Global Nuclear Fuel

Subject: Response to NRC's RAI for NPC Shipping Package dated 1/26/07

Reference: (1) NRC CoC No. 9294, Docket 71-9294 (TAC L24033)
(2) Letter, S.P. Murray to Director, SFPO, 10/3/06
(3) Letter, S.P. Murray to Director, DSFST, 2/26/07

Attachment 1

Exhibit 2-1a – ICCA Packing Details

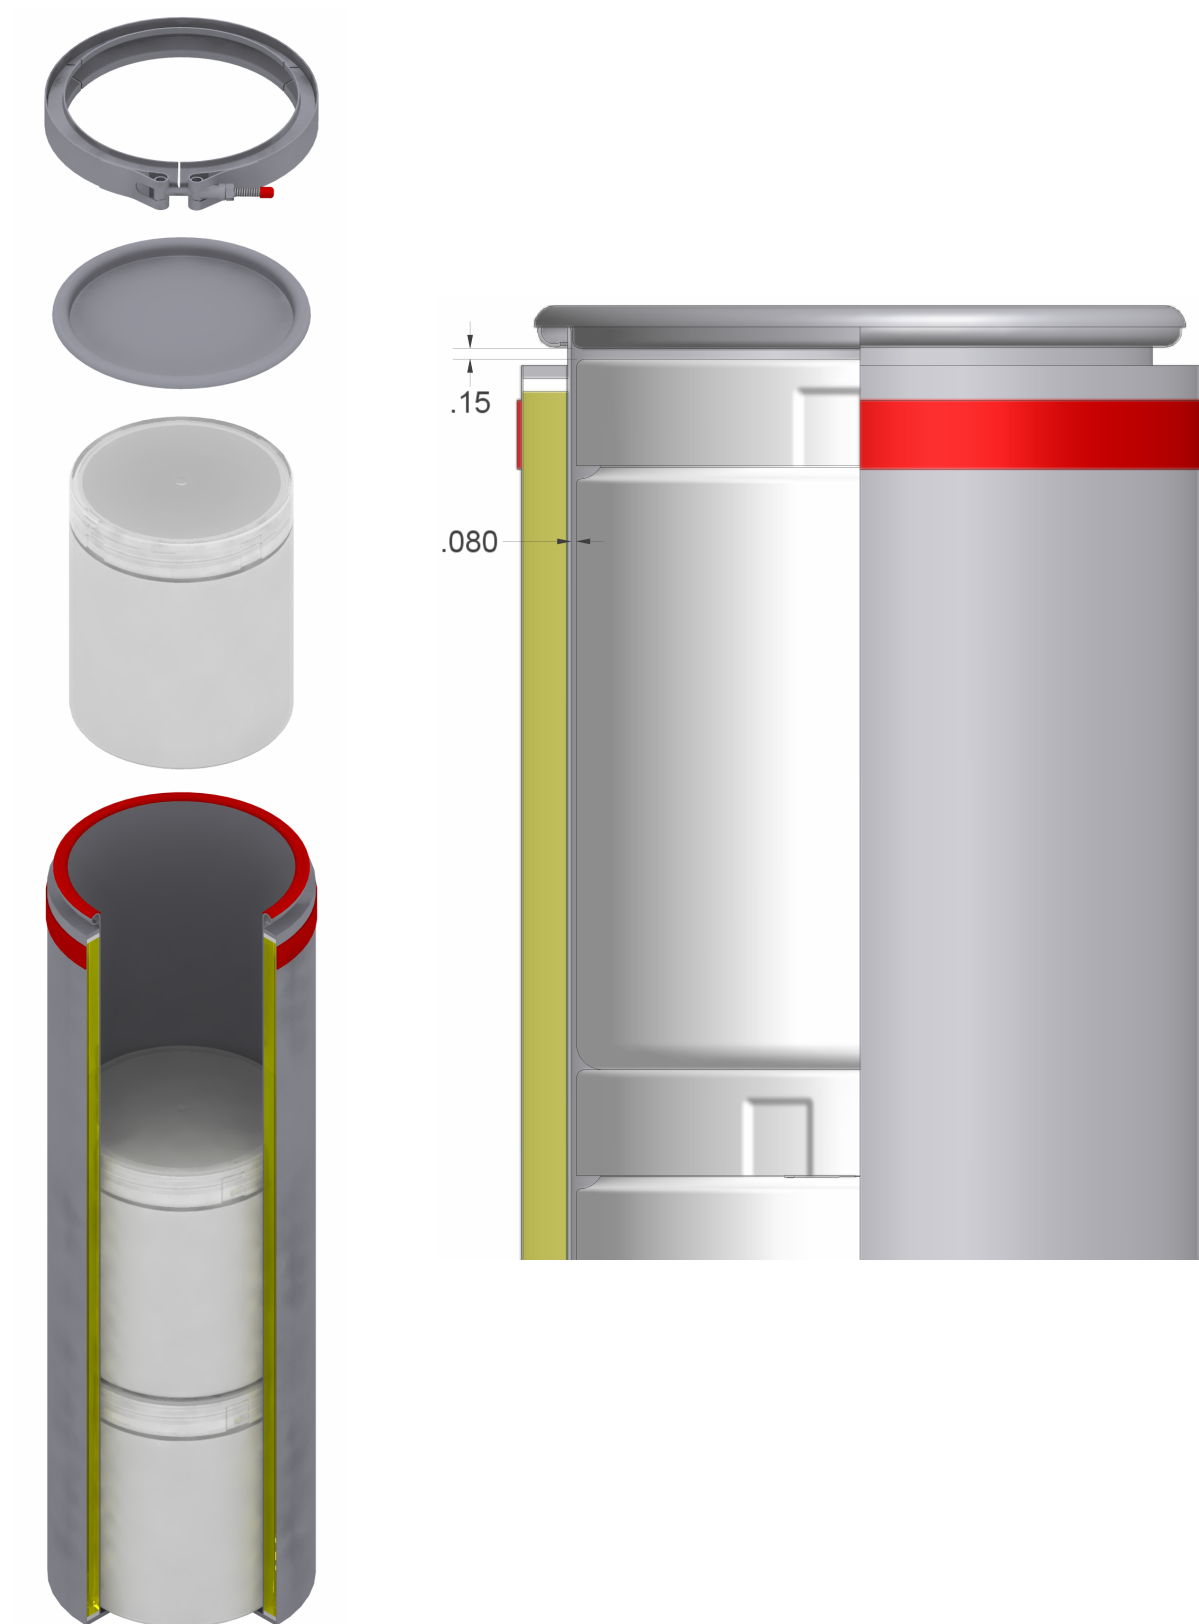
2-1. *Confirm by test or analysis or both that the ICCAs with contents in either plastic or metal receptacles the containment barrier will not be adversely affected as a result of the hypothetical accident condition (HAC).*

The internal arrangement/layout may influence the structural performance and containment function of the ICCA. Therefore, results of either a test or an analysis, or both, are needed to demonstrate that for a given layout, the ability of the ICCA to retain fissile material under the HAC will not be impaired as a result of the impact by the receptacles.

The current payload configuration of the ICCAs includes three polyethylene receptacles/bottles stacked on top of each other. As shown in Exhibit 2-1a, the bottles are tightly packed into the ICCA to limit the movement of the payload. The radial gap between the bottle wall and ICCA wall is 0.08 inches, and the approximate gap between the top bottle lid and ICCA lid is 0.15 inches in the axial direction.

During the design and analysis process of the NPC, the decision was made to evaluate the container using the worst-case payload configuration. For the drop test sequence documented in Appendix 2.10.1 of the SAR, a bounding payload was chosen. Prior to free drop, puncture, and thermal testing, the nine ICCAs of each certified test unit (CTU) were loaded with loose sand and bagged lead shot to simulate the maximum payload of 132 pounds (60 kg) of uranium oxide powder. Justification for the use of loose payload and ignoring the inner packing is:

- This loose payload configuration was considered conservative since the maximum payload is applied to the closure region of the ICCA. Additional packaging was considered an enhancement to the confinement capabilities of the ICCA and limits dispersal of the contents.

- Loose materials were considered a better test of the sealing surface of the ICCA. In reality, the polyethylene bottles limit the total movement of the contents and potential damage to the ICCA imposed by the contents.

- The polyethylene bottles were considered to provide little structural support during the accident sequence since the bottles are fabricated from material that is soft in relation to the steel inner shell of the ICCA. Therefore, additional loading or damage to the ICCA was not anticipated because of using the polyethylene bottles.

- During normal production, the bottles are nearly filled with material. The total mass of the three ICCAs and contents is less than the 60kg design limit. Therefore, loading of the ICCA during the HAC drop sequence is bounded by the CTU payload. The CTU maximized the available kinetic energy and bounds the deformation expected during the drop sequence.

Exhibit 3-1a – ICCA ANSYS Axisymmetric Thermal Model

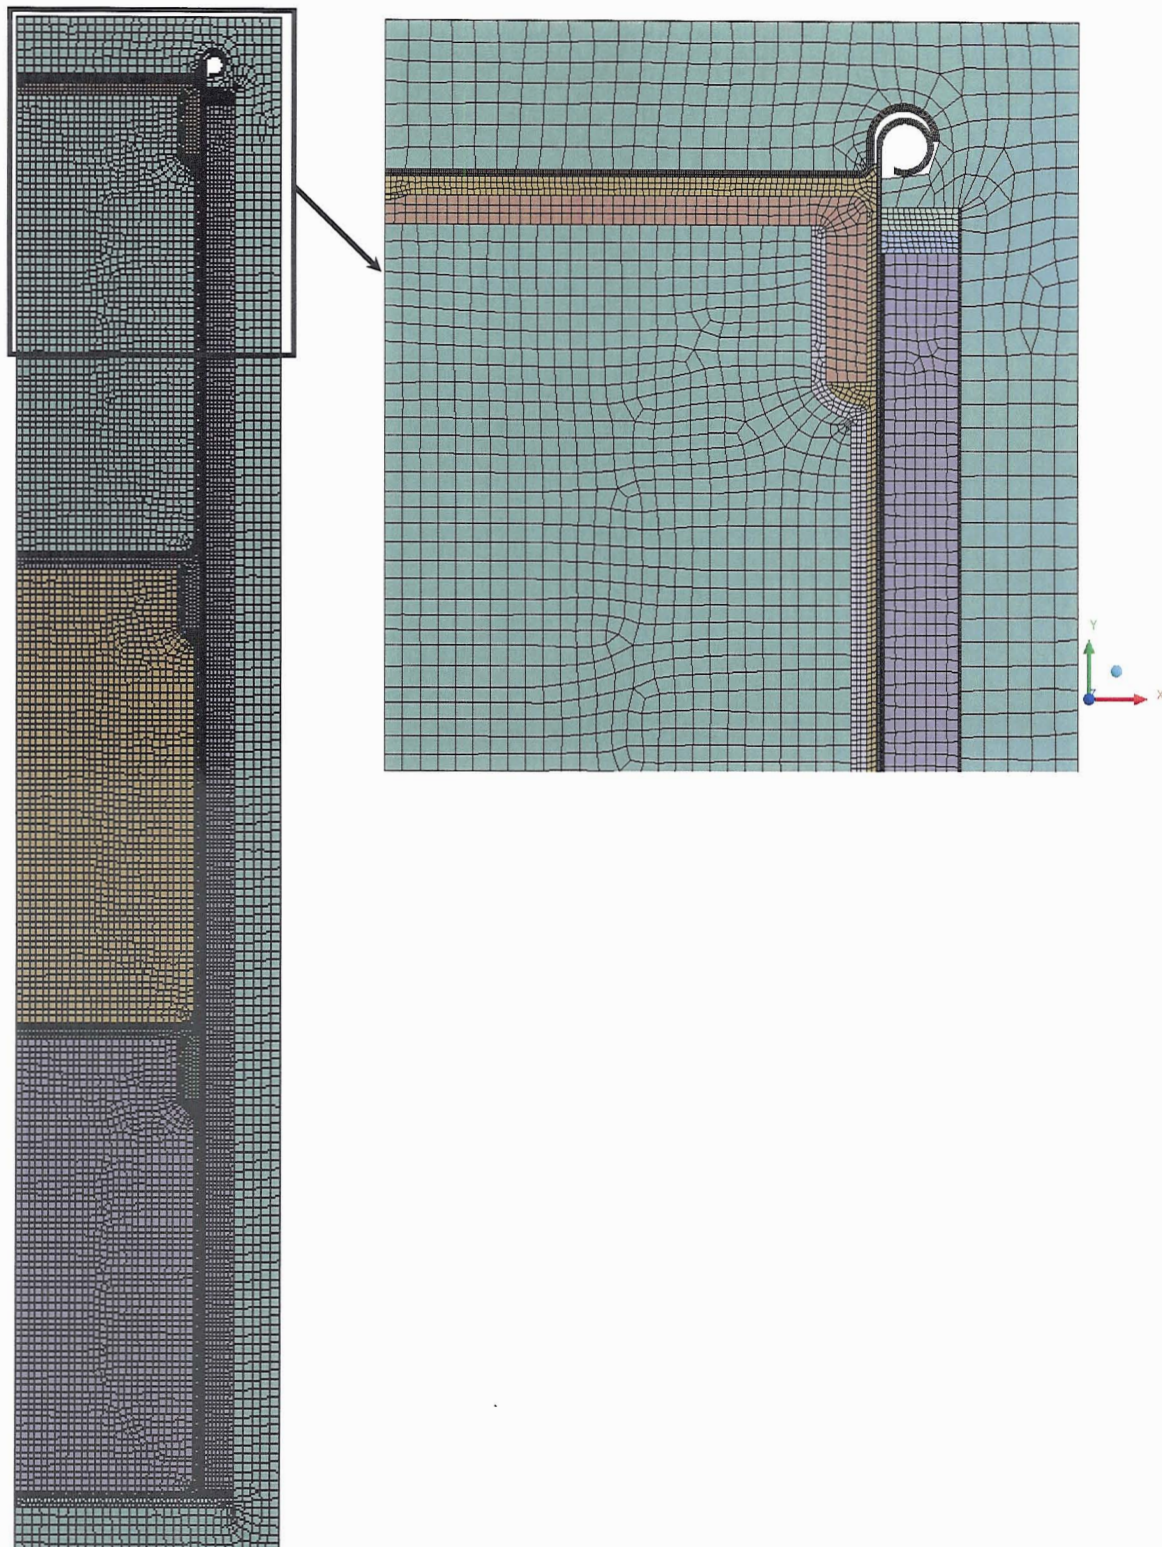
3-1. *Provide the results of an evaluation of the effect of the HAC fire on the “plastic receptacles” within the ICCAs.*

To determine the thermal performance of the ICCAs and plastic receptacles, i.e. polyethylene bottles, during the HAC fire, an axisymmetric finite element model was first developed using ANSYS. The model includes the ICCA, three polyethylene bottles, and UO₂ contents. For consistency, the model uses the same material properties provided in Chapter 3 of the SAR. Exhibit 3-1a shows the ANSYS model.

The analysis was solved by applying an initial ambient temperature of 132°F and the maximum-recorded ICCA temperature of 365°F to the outer edges of the model [NPC SAR Appendix 2.10.1, *Certification Tests*]. This analysis conservatively assumes that the ICCA wall is instantaneously exposed to the maximum temperature achieved during the fire test and remains at this temperature for one full hour. The results show that after one hour, a maximum polyethylene bottle temperature of 338°F is achieved. Exhibit 3-1b shows the sidewall temperature time history of each polyethylene bottle.

GNF-A Drawing Number:
SK105E4037, Sheet 2, Revision 1

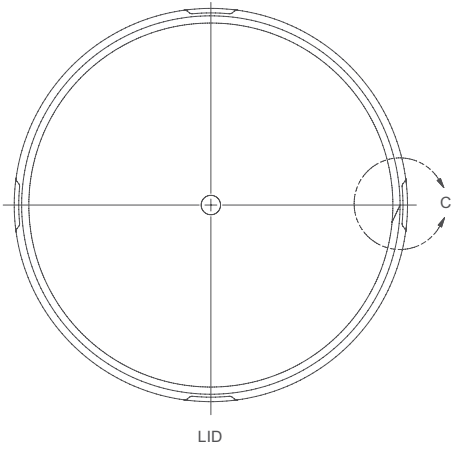
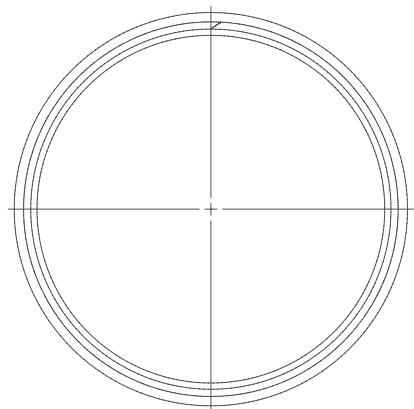
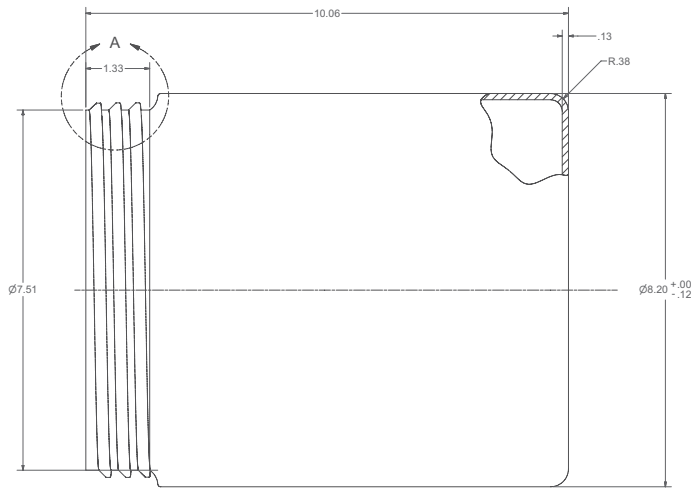
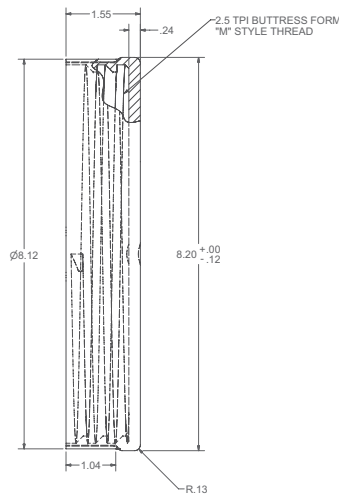
- 1.1 *Submit a revised drawing of the NPC Powder Container. Drawing SK105E4037, sheets 1 through 3, Revision 1, appears to contain information not appropriate for inclusion within a (CoC). Also, confirm that the NPC Powder Container depicted in this revised drawing will be the "plastic receptacle" noted in CoC No. 9294, Revision 4, Condition 5.(a)(3)(b), footnote No. 4. If so, the SAR should be revised to reflect this.*

A CoC is a regulatory instrument to control the design of a package used for transportation of radioactive material. See 10 CFR 71.4. While the bottle and lid appear to be components associated with Model No. NPC packaging, the NPC skid base and NPC skid lid do not appear to be packaging components.

Drawing SK105E4037 sheet 1 and sheet 3 were submitted in error. Drawing SK105E4037, sheets 1 and 3 are not packaging components and will be deleted as references in the SAR Chapter 1.3 Appendix.

Drawing SK105E4037 sheet 2 is submitted with this response.

The SAR Chapter 1 (Section 1.3) has been revised to reflect this change and is submitted with this response.
